Cumberland County Subdivision and Land Development Review Report

Municipality:	<u>Silver Spring</u>	Surveyor/ Engineer:	<u>Advantage Engineering Services, LLC</u>	Owner/ Developer:	<u>Fishel Properties, LLC</u>
Plat Title:	<u>Stream Line Painting</u>				
Plat Status:	<u>Final</u>	Plat Type:	<u>Land Development</u>		
# of New Lots:	<u> </u>	# of New Dwelling Units:	<u> </u>	New Acreage Subdivided/Developed:	<u> </u>
				Total Tract Acreage:	<u>1.10</u>
Zoning District:	<u>Light Industrial</u>		Proposed Land Use:	<u>Painting Contractor</u>	
Date Received:	<u>7/7/2020</u>	County Review:	<u>7/20/2020</u>	Reviewed by:	<u>SH</u>
				Checked by:	<u> </u>

FINAL LAND DEVELOPMENT PLAN FOR STREAM LINE PAINTING KEENER DRIVE LOT 3 SILVER SPRING TOWNSHIP CUMBERLAND COUNTY, PENNSYLVANIA

Keener Drive - Lot 3
SITE PLAN

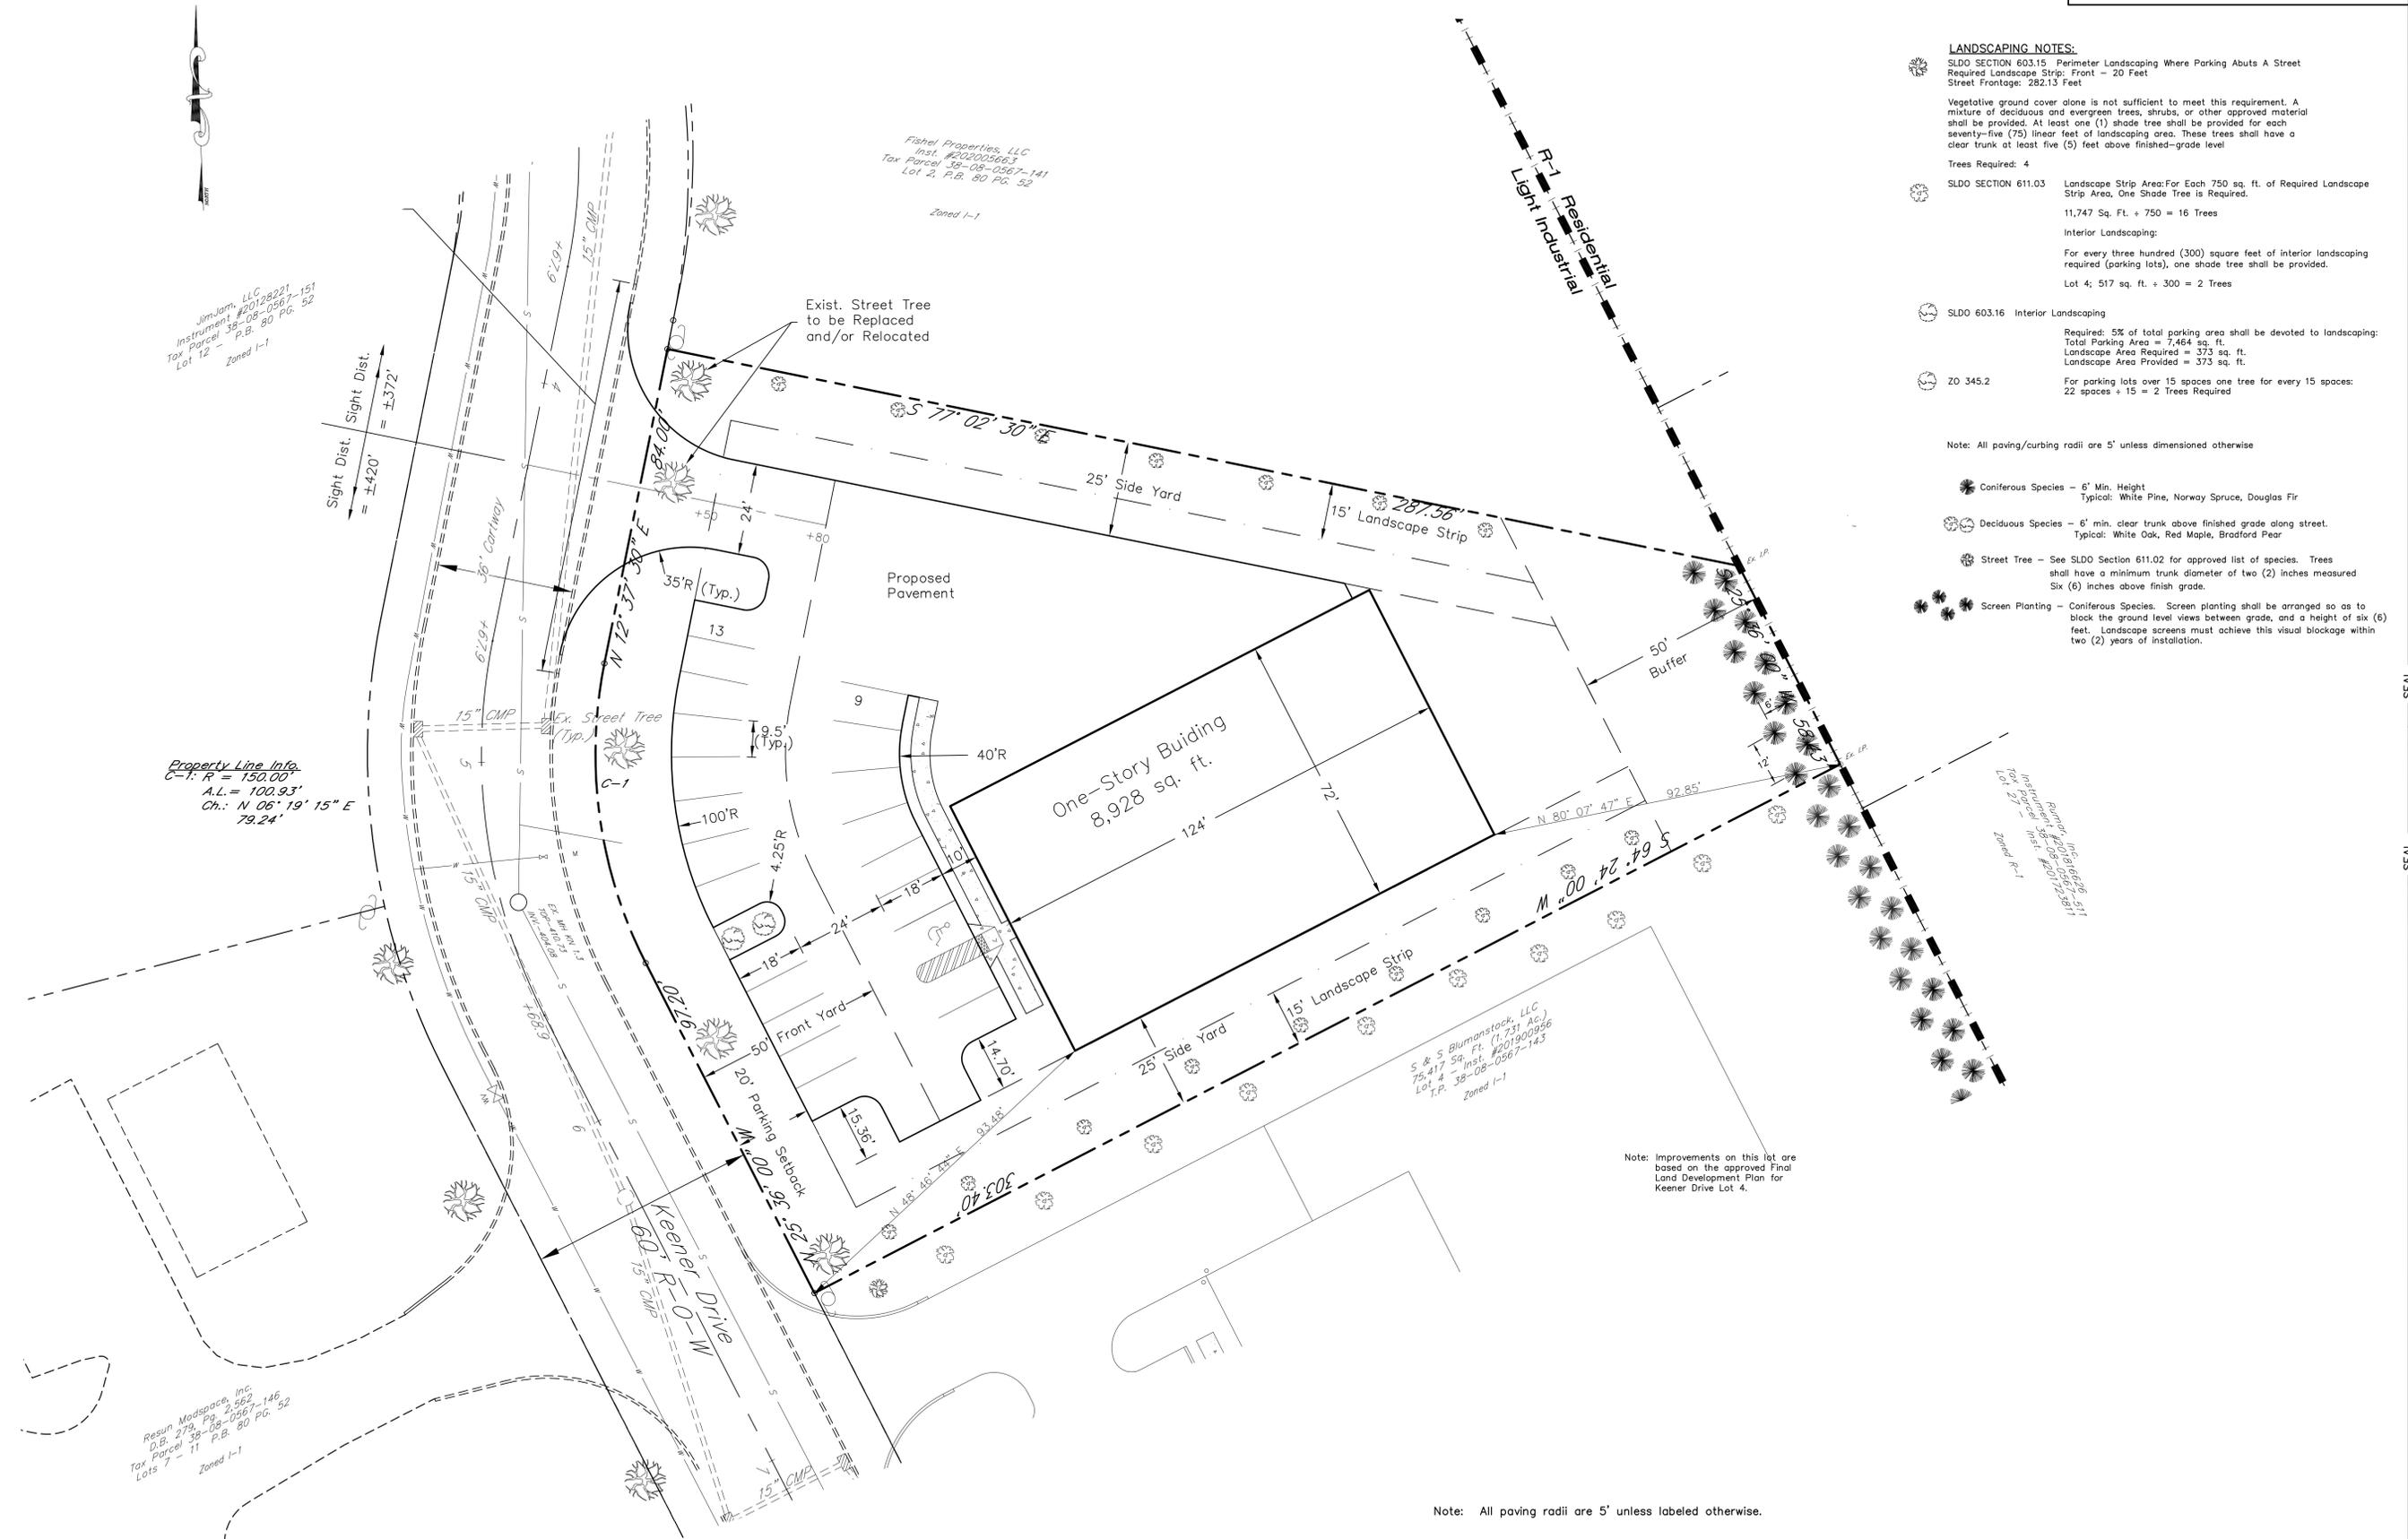
9. The sight distance figures on Sheet 3 should include the required and provided figures (SLDO 602.18.3.H).
10. A clear sight triangle should be provided at the proposed entrance (SLDO 602.18.3.H).

13. Sheet 3 notes that 5% of the total parking area (7,464 square feet) shall be devoted to landscaping. Township should determine if this area includes the “Proposed Pavement”.
14. When obtaining the county signature for the final plan recording process, the applicant / engineer should provide a CD that includes a .dwg AutoCAD file that shows all of the parcel boundaries, lot lines, building footprints, road rights-of-way and the edge of pavement. For more information, please visit the Cumberland County Planning Department website at: <https://www.ccpa.net/3185/Plan-Submission-Recording-Procedures>.
